# Eskew Dumez Ripple<sup>+</sup>

## **ADDENDUM NO. 1** 01/09/2026

**RE:** Odenheimer Phase 1  
EDR Project No. 22071

**FROM:** Eskew+Dumez+Ripple  
400 Lafayette Street, Suite 300  
New Orleans, Louisiana 70130  
(504) 561-8686

07 DOWNSPOUT CONNECTION, TYP.

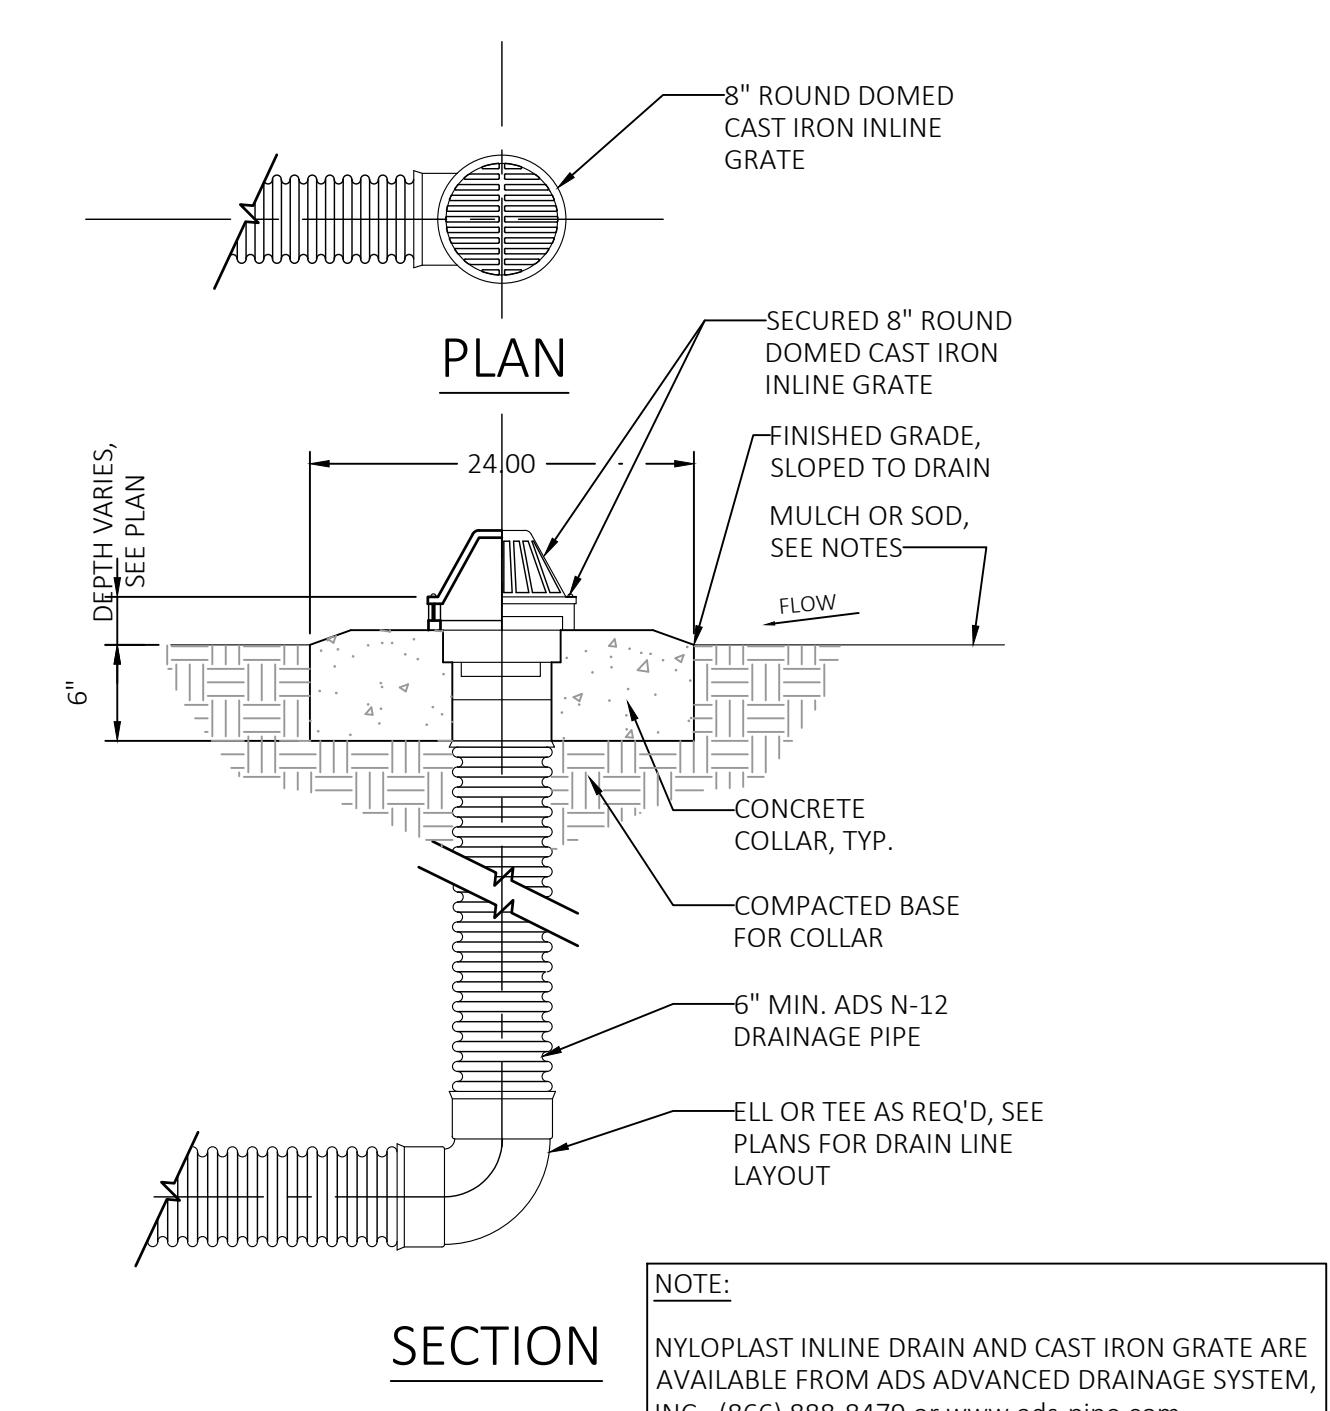
22. Sheet C12.4: Added detail 07

E1.11

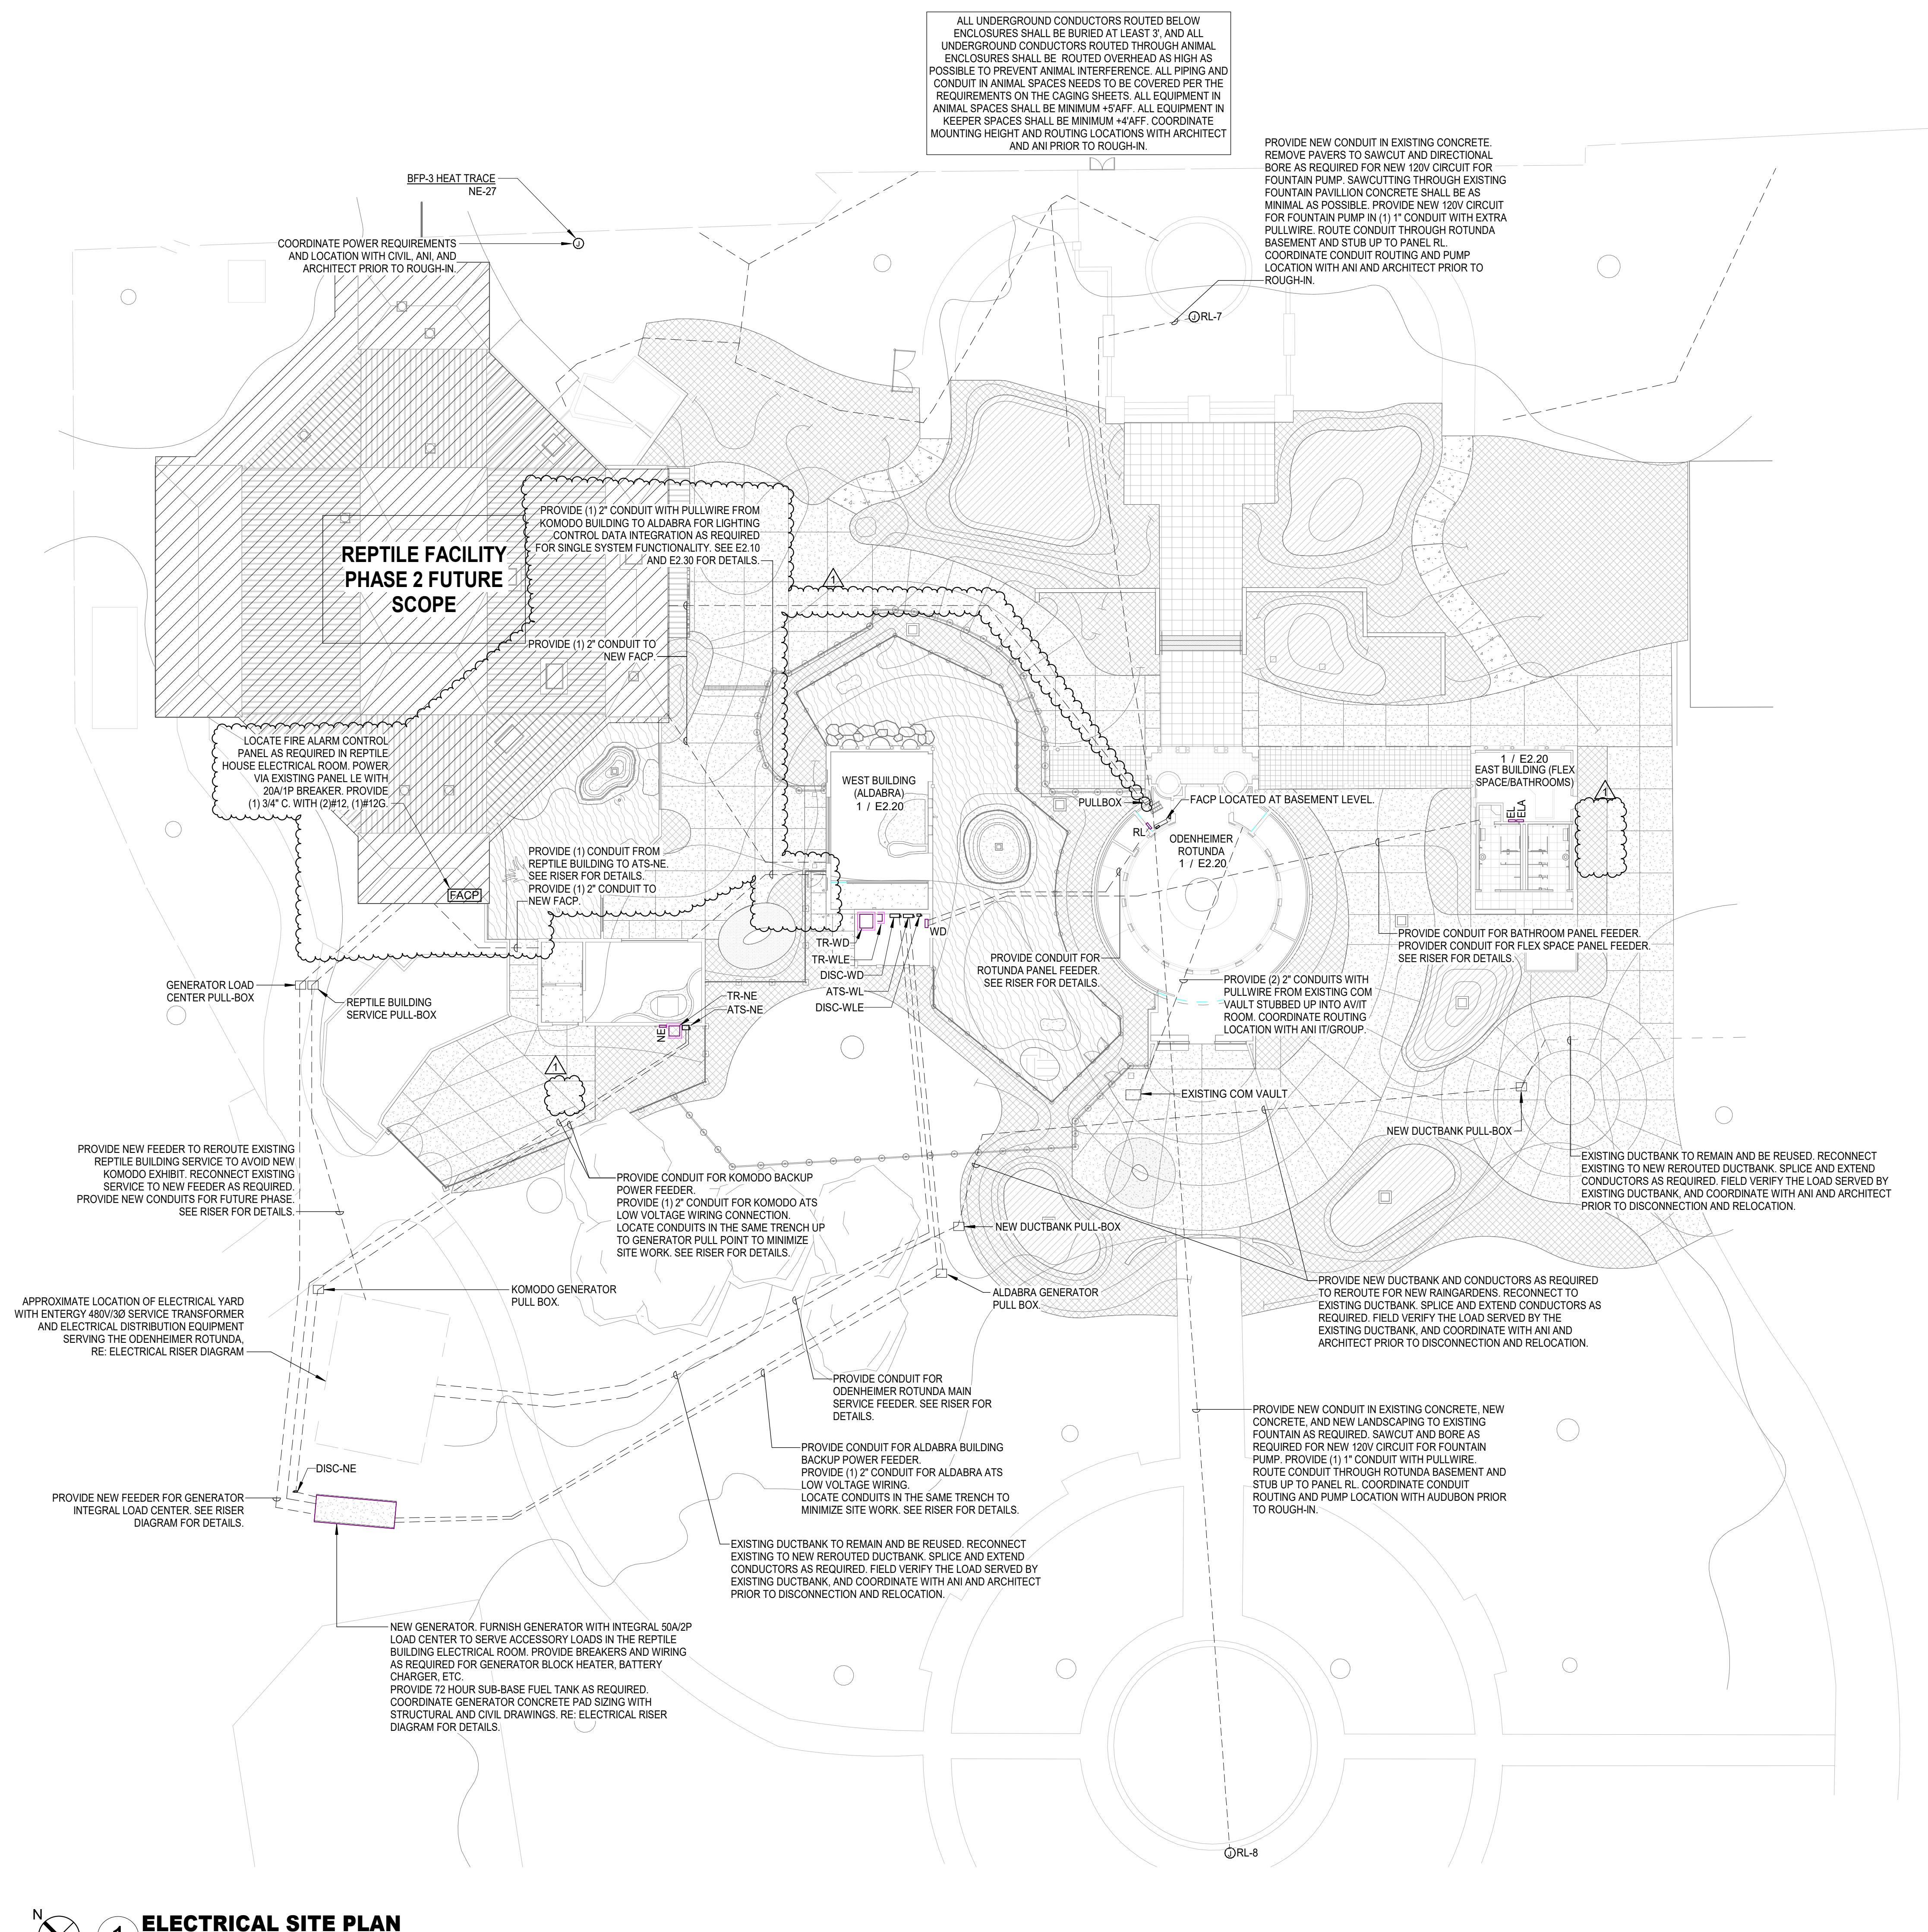
23. SHEET E1.11 – Revisions to power shown for backflow preventers, Adjustment to FACP location and addition of required conduit runs to each building
24. SHEET E2.10 – Added fire alarm devices to Aldabra Exhibit per owner direction to include non-code required fire alarms in all buildings except for bathroom building.

FIRST FLOOR PLAN - KOMODO

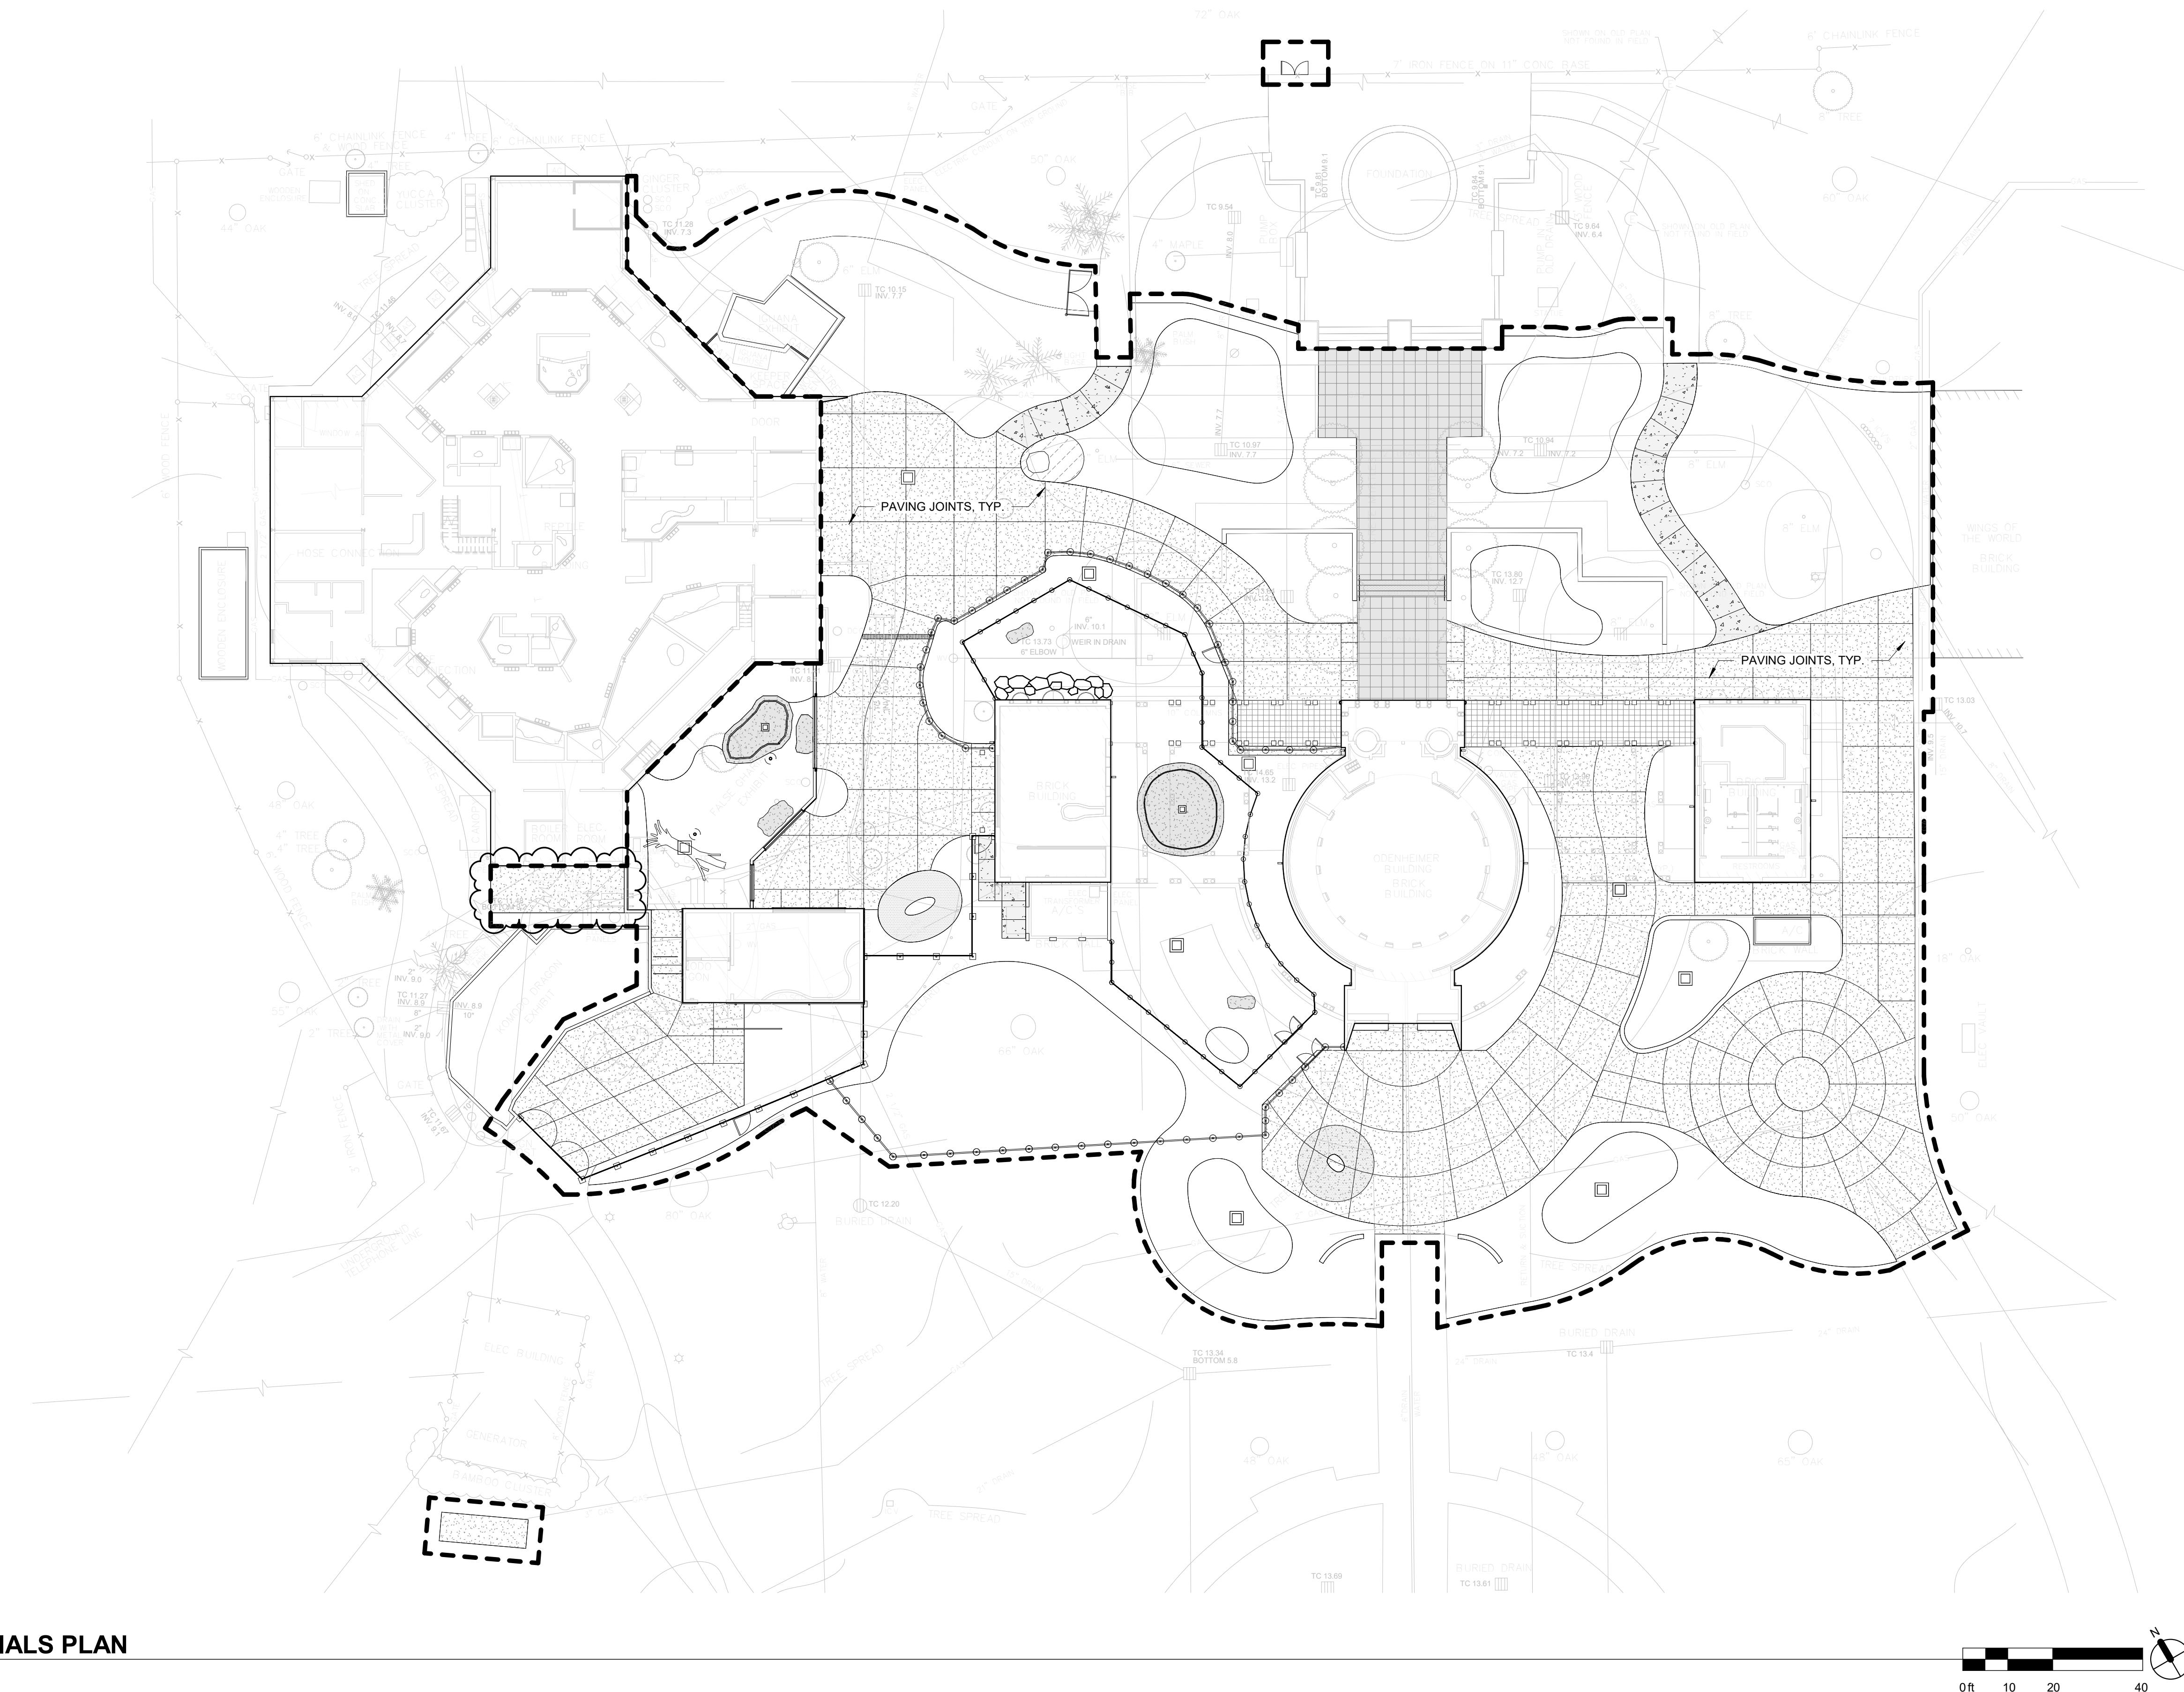
25. SHEET E2.30 – Added fire alarm devices to Komodo Exhibit per owner direction to include non-code required fire alarm in all buildings except for bathroom building.
